**Palo Verde
Nuclear Generating Station**
P.O. Box 52034
Phoenix, AZ 85072
Mail Station 7602
Tel 623.393.5102

Subject: **Palo Verde Nuclear Generating Station Units 1, 2, and 3
Docket Nos. STN 50-528, 50-529, and 50-530
Renewed Operating License Number NPF-41, NPF-51, and NPF-74
Application to Revise Technical Specifications to Make Necessary
Administrative Changes**

**Description and Assessment of Proposed License
Amendment**

Subject: License Amendment Request to Make Miscellaneous Administrative Changes

Figure 3.7.17-1
ASSEMBLY BURNUP VERSUS INITIAL ENRICHMENT
for
Region 2

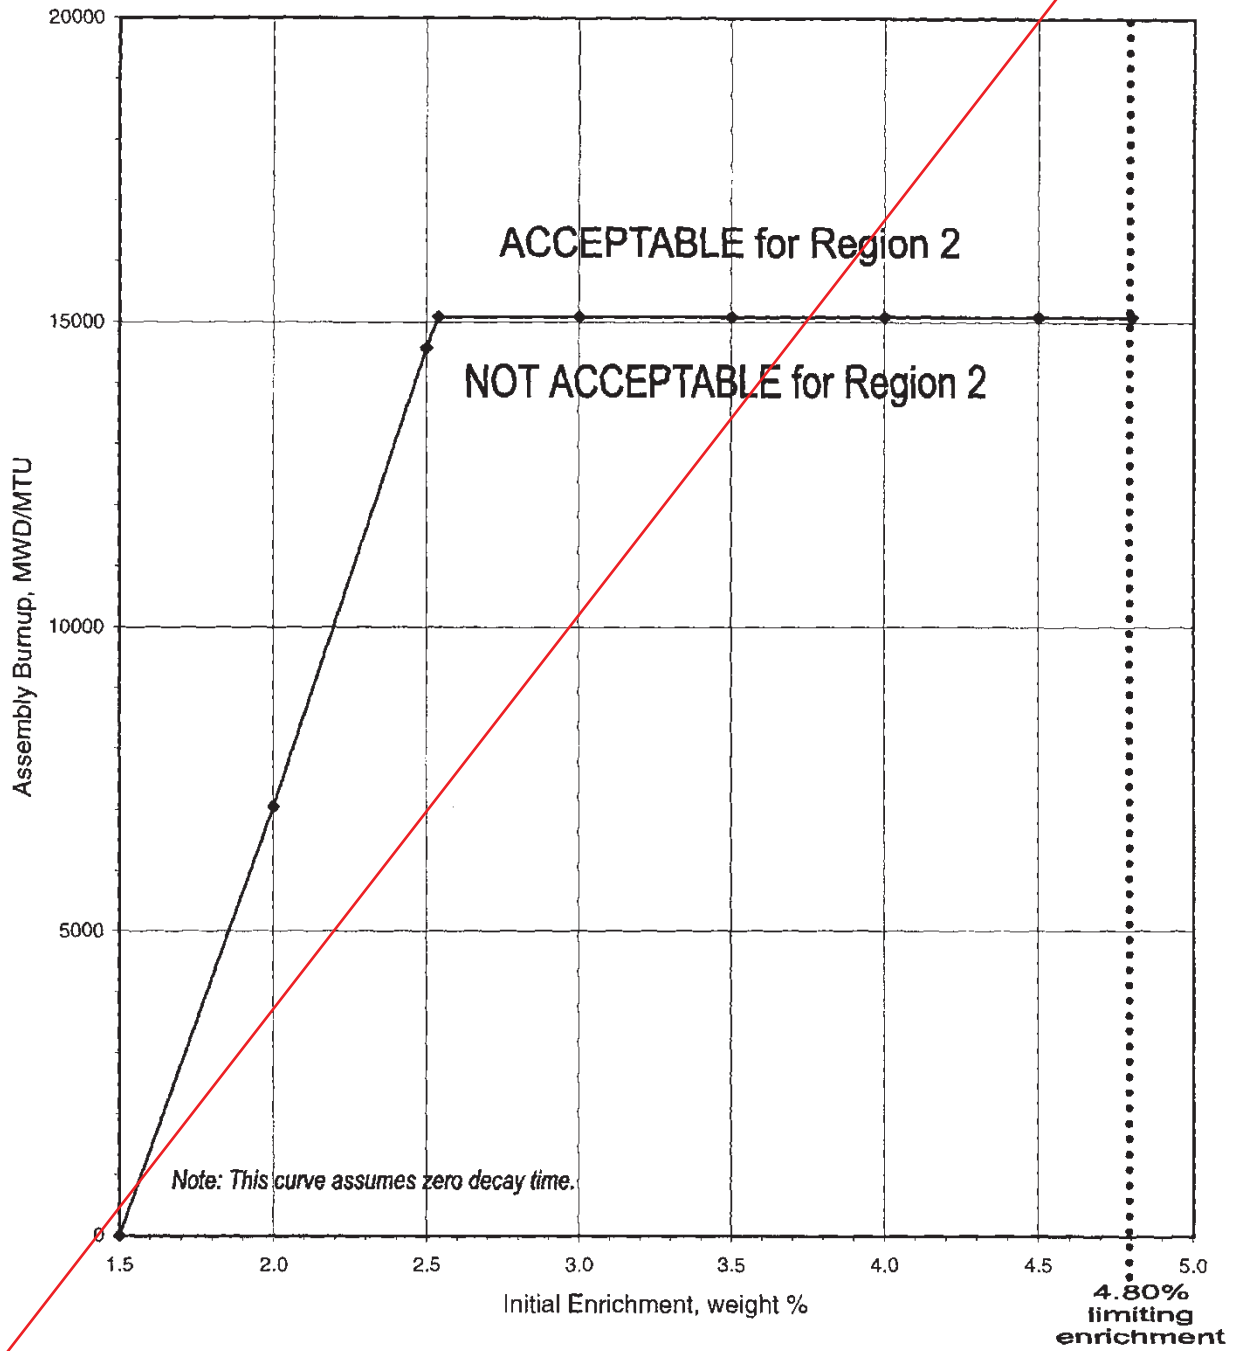
This proposed LAR will modify PVNGS TS Sections 3.7.17, *Spent Fuel Assembly Storage*, 4.3, *Fuel Storage*, and 5.5.21, *Spent Fuel Storage Rack Neutron Absorber Monitoring Program*, to remove the "Before SFP transition" pages and revise the "After SFP transition" pages.

Removal of the "Before SFP transition" pages is administrative. These pages were only necessary during the transitional phase of the SFP physical changes. With all SFP configuration changes complete, the "Before SFP transition" pages are no longer applicable or necessary.

Delete page

Figure 3.7.17-2
ASSEMBLY BURNUP VERSUS INITIAL ENRICHMENT
for
Region 3
(at decay times from 0 to 20 years)

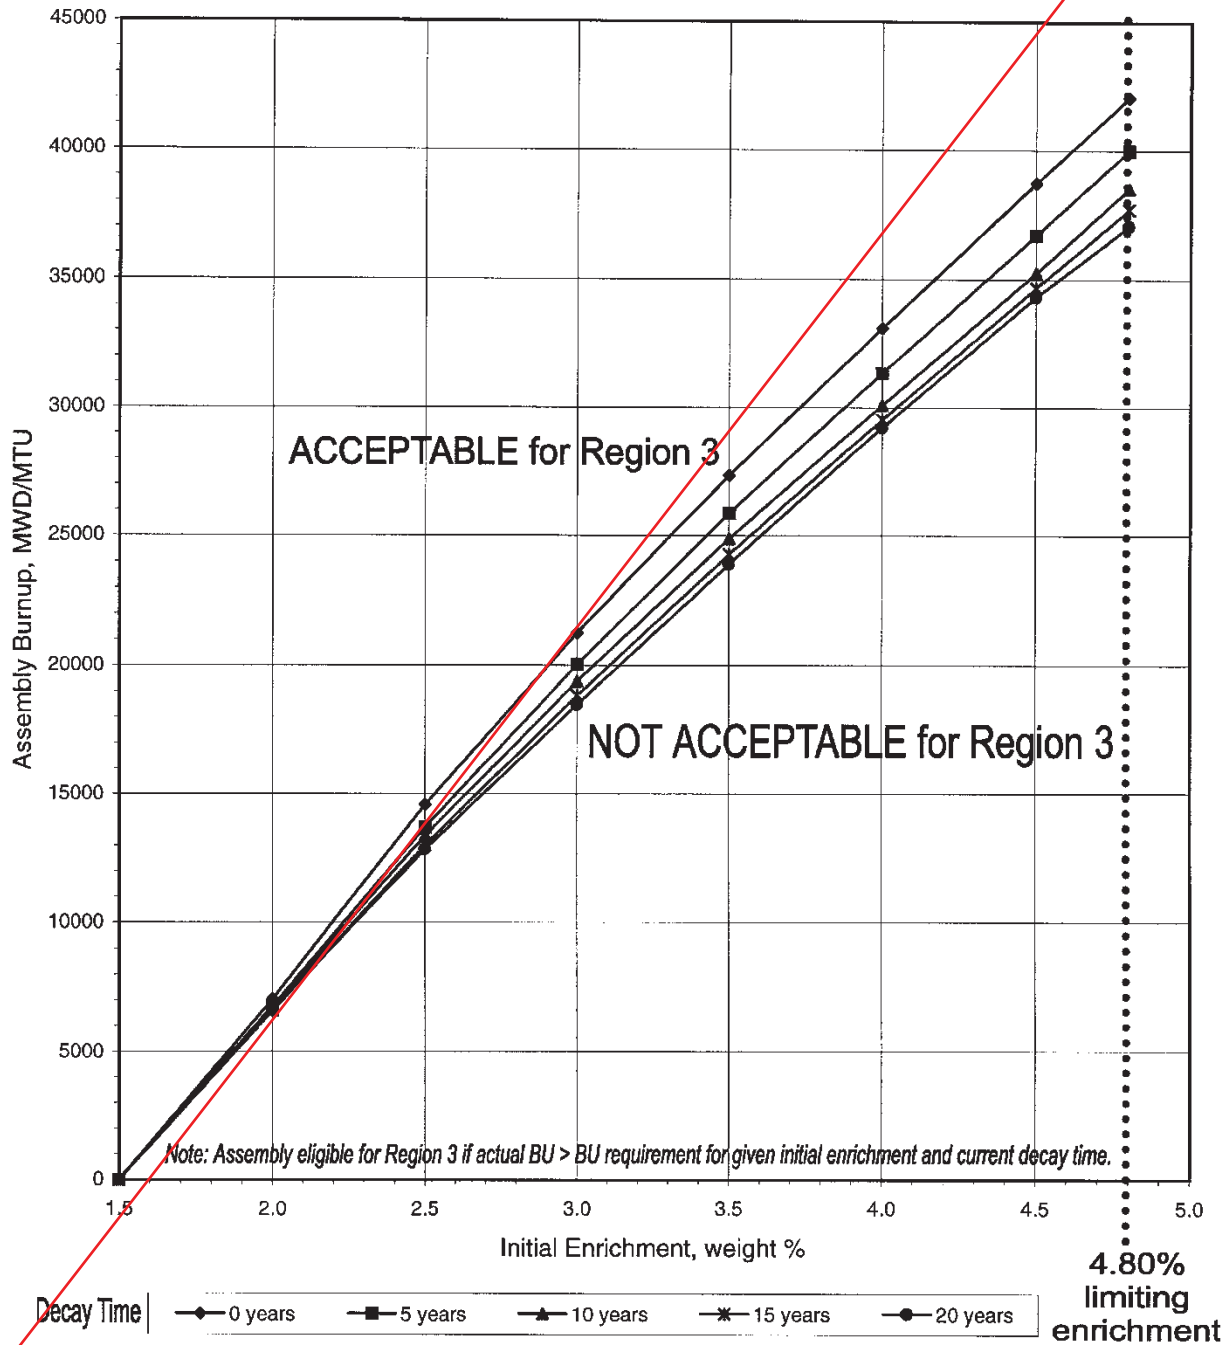
Delete page

Figure 3.7.17-3
ASSEMBLY BURNUP VERSUS INITIAL ENRICHMENT
for
Region 4
(at decay times from 0 to 20 years)

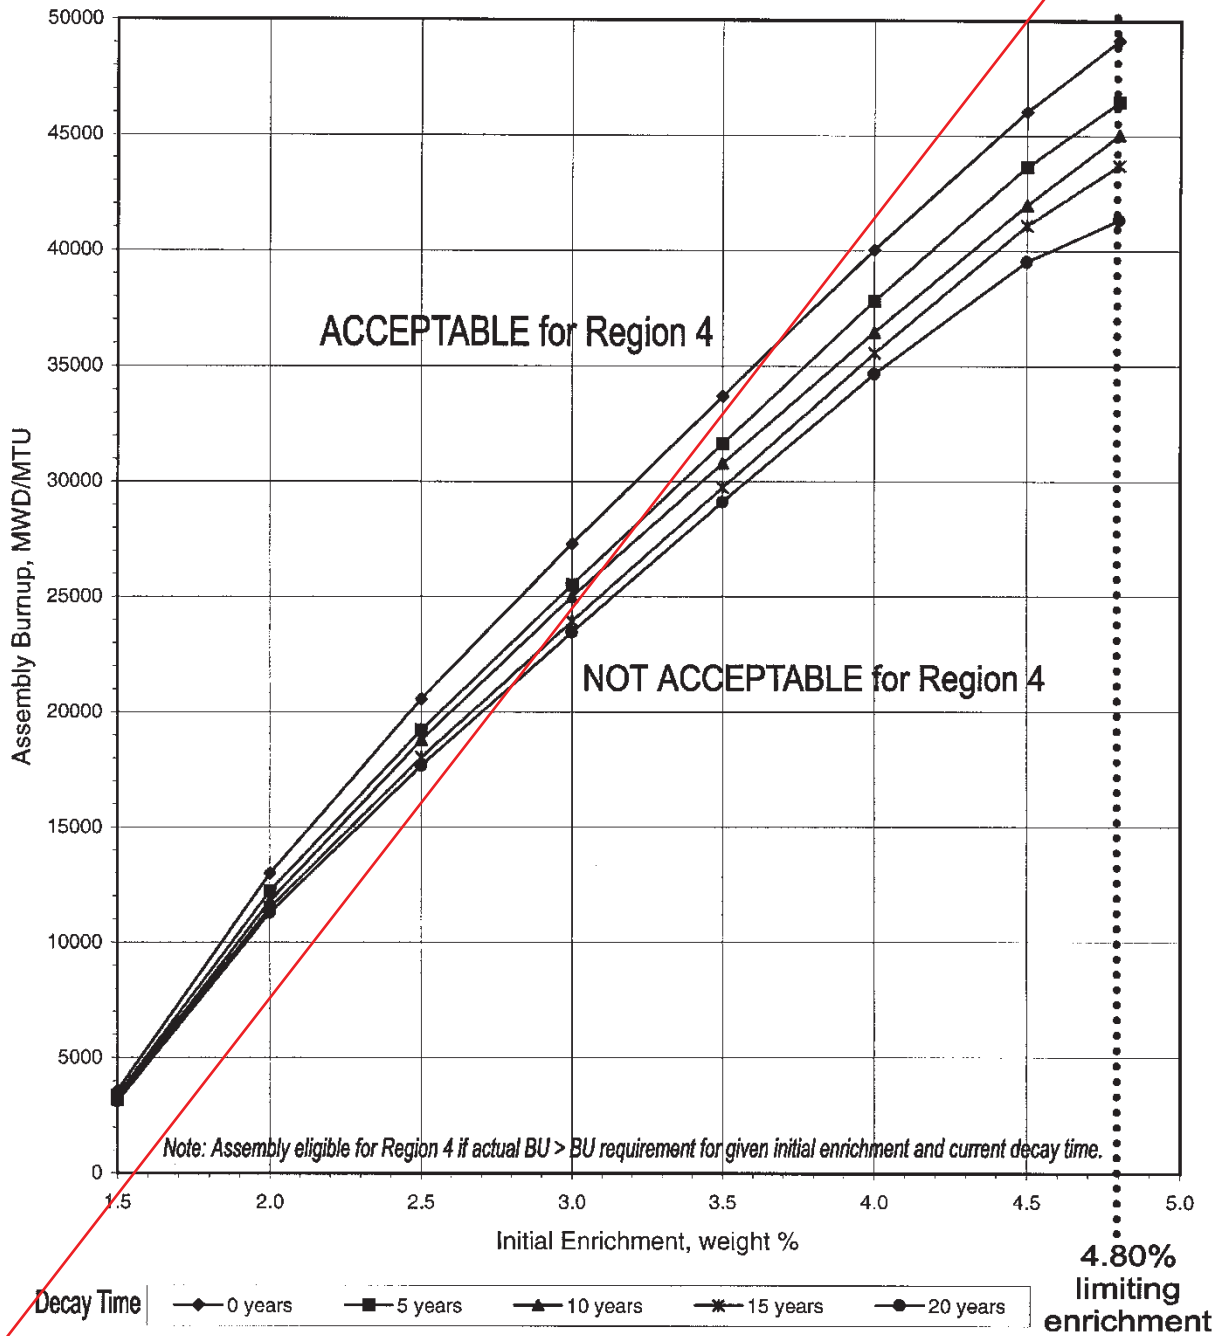
Delete page
